CA 440-06 Smith, James  
VAR 06-3336

Re: Variance 06-3336 Smith-Revised

Case No. 06-3336

BUILDING PERMIT PLAT

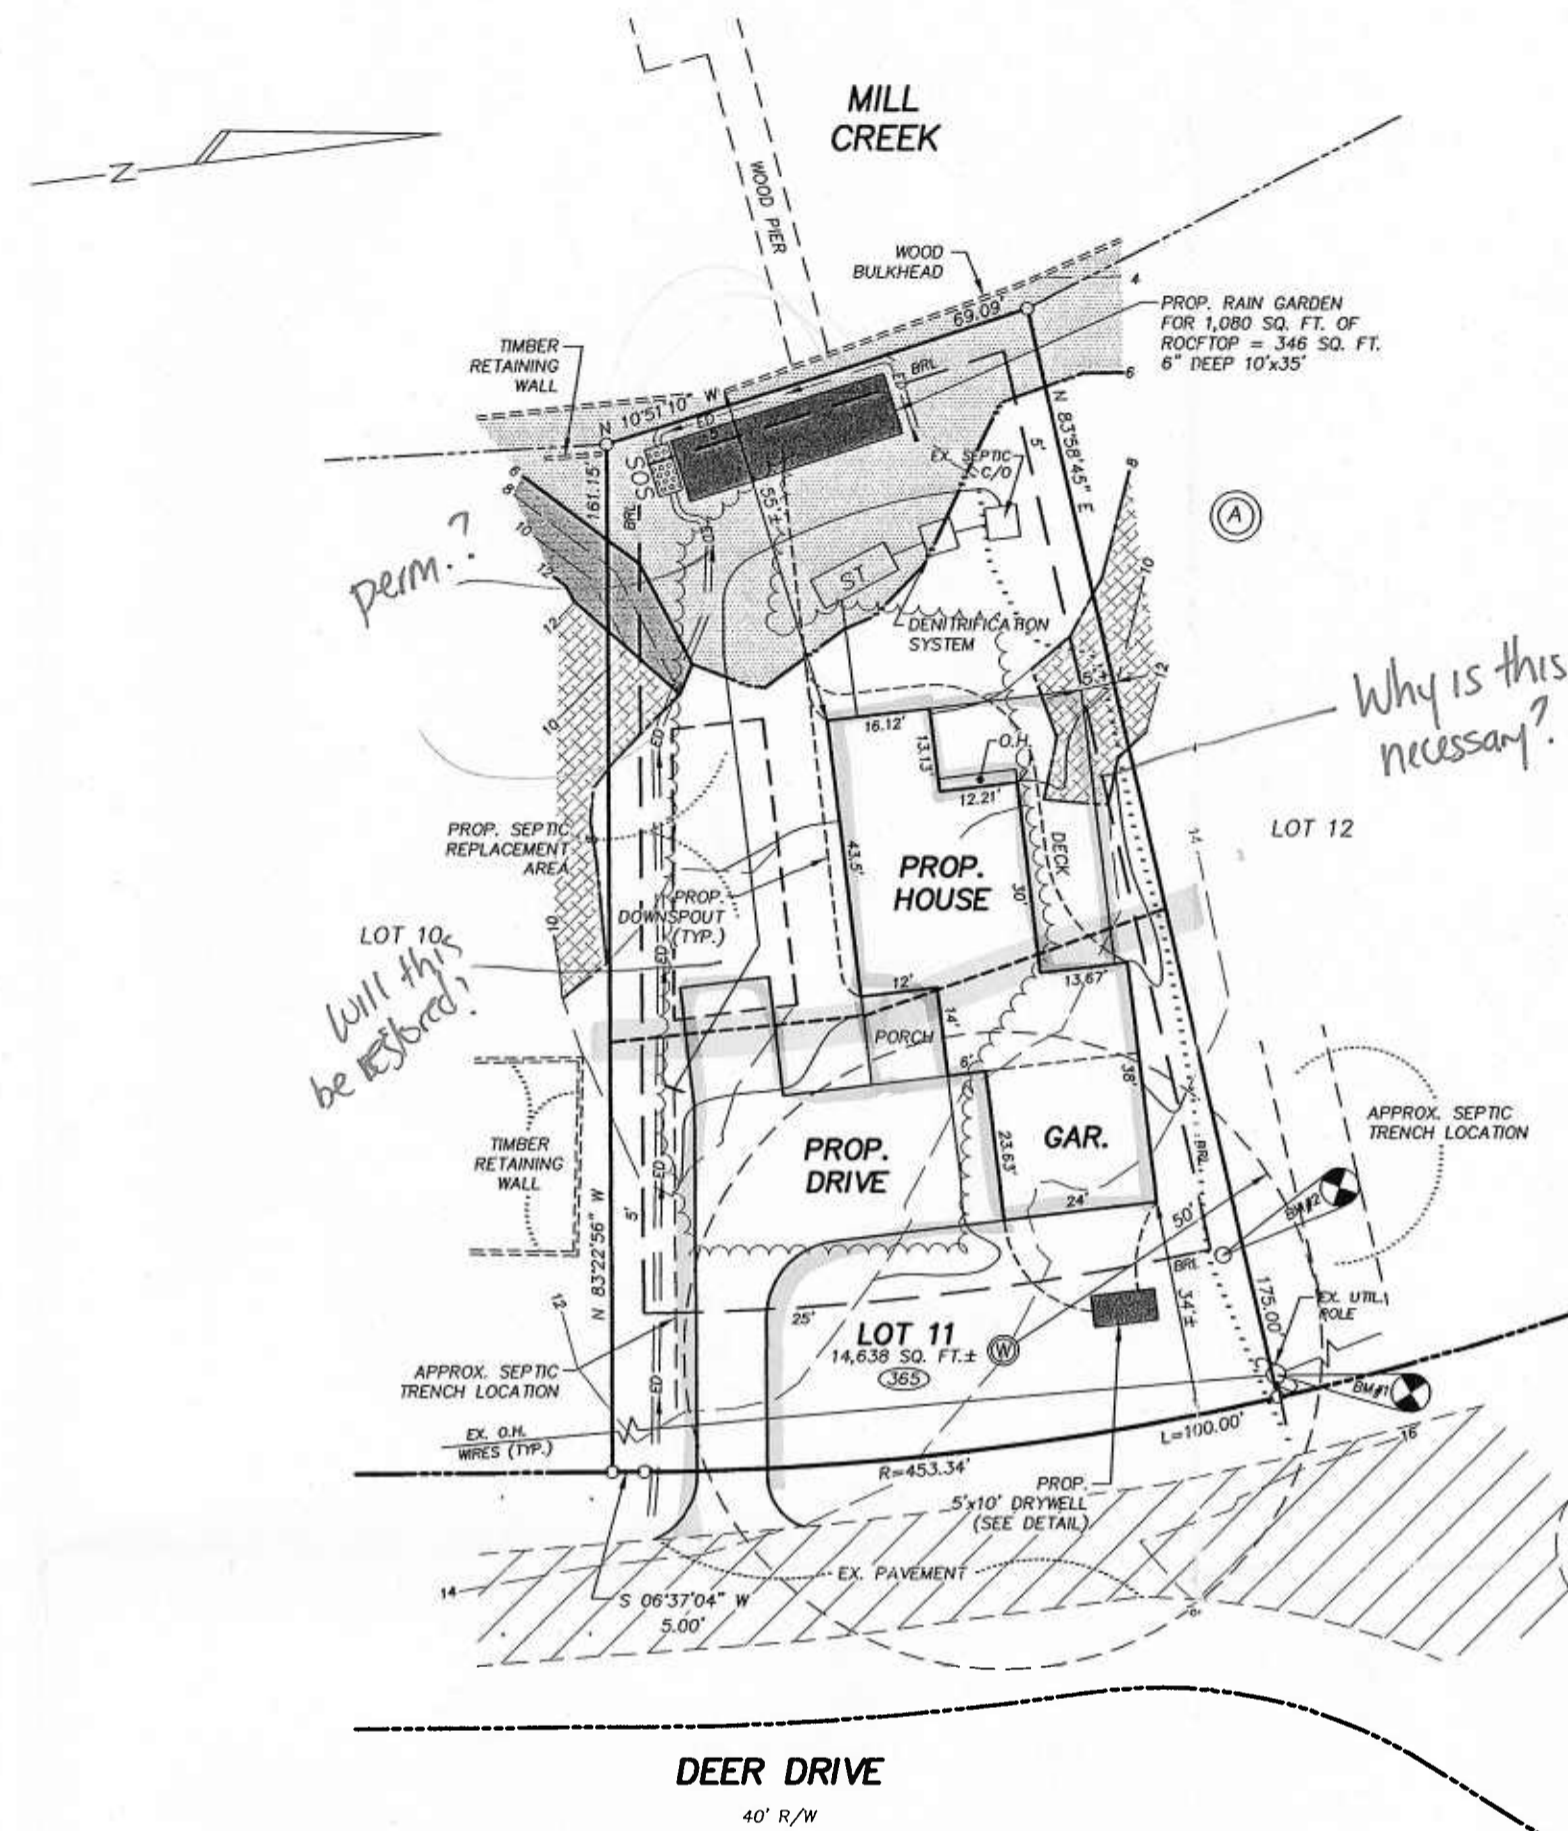
In evaluating the features of the site plan, this office also questions the location of the proposed rain garden. Generally, the Commission encourages the use of rain gardens as best management practices. In this case, the rain garden is proposed 5 feet off of the existing wooden bulkhead. Installation of the rain garden requires excavation of the existing soil materials and utilizing a design intended to retain water for periods of time. Given these factors, we question whether the rain garden could pose a threat to the integrity of the bulkhead and whether a heavy storm might result in direct overflow into Mill Creek. We recommend that the applicant consult with the County's engineering division prior to or in conjunction with the Board's approval.

- 6) Rain Gardens concerns
- 6" excavations only?
- 7) What is the new total imp.?
- No Δ?

Due to the outstanding concerns identified within this letter, we are unable to offer support for the variance as requested. We recommend that the Board evaluate whether it is possible to utilize an alternative dwelling design which eliminates the need to disturb steep slopes and that the Board consider whether the rain garden would be more appropriately located elsewhere on the property.

11. The rain garden as proposed is located within a 100-year flood plain. The Applicant shall explore with the Health Department the possibility of moving the proposed rain garden located adjacent to Mill Creek back from the Creek and the bulkhead. The proposed rain garden shall be enlarged and/or moved if approved by the Health Department. There shall be no tree removal for an enlarged/moved rain garden. If Health Department approval for the enlarged/moved rain garden is not obtained, the rain garden shall remain in its current location and must be planted with salt tolerant native plant species.
